Project	IEEE 802.16 Broadband Wireless Access Working Group < http://ieee802.org/16 >	
Title	Uplink control channels	
Date Submitted	2004-03-11	
Source(s)	<p>JeonTae Oh, Seungjoo Maeng, Soonyoung Yoon, Jaeho Jeon, Youngbin Chang, Chiwoo Lim</p> <p>Samsung electronics. Co. Ltd. Dong Suwon P.O.Box 105, 416, Maetan-3Dong, Yongtong-Gu, Suwon-City, Gyeonggi-Do, Korea 442-600</p>	<p>Voice: 82-31-279-3791 Fax: [Fax Number] ojtae@samsung.com sjmaeng@samsung.com soon.young.yoon@samsung.com jhjeon@samsung.com yb.chang@samsung.com chiwoo.lim@samsung.com</p>
Re:		
Abstract	Uplink control channels is proposed.	
Purpose	Adoption of the proposed Uplink control channels into 802.16-REVd	
Notice	This document has been prepared to assist IEEE 802.16. It is offered as a basis for discussion and is not binding on the contributing individual(s) or organization(s). The material in this document is subject to change in form and content after further study. The contributor(s) reserve(s) the right to add, amend or withdraw material contained herein.

Uplink control channels

Proposed Text Changes

Figure 1 – Differential Modulation and Subcarrier Mapping for a CQI channel

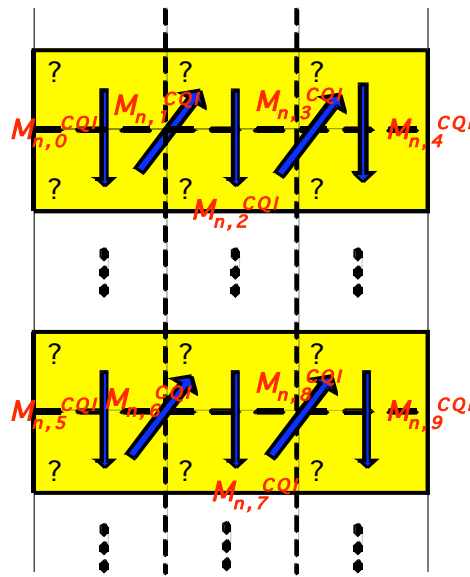
The CQI channel is differentially QPSK modulated. After CQI encoding, the CQI codeword symbols are entered serially to the differential QPSK modulator. Then the differentially modulated symbols are mapped to the subcarriers which are allocated to a CQI channel. The 20-bit codeword is separated into two 10-bit groups and the first 10 bits make one group and the last 10 bits make another group. Each group is modulated separately and mapped to two of 2-subcarrier by 3-symbol bunches according to the CQI allocation. The first group is mapped to the first and the third bunches and the second group is mapped to the second and the fourth bunches.
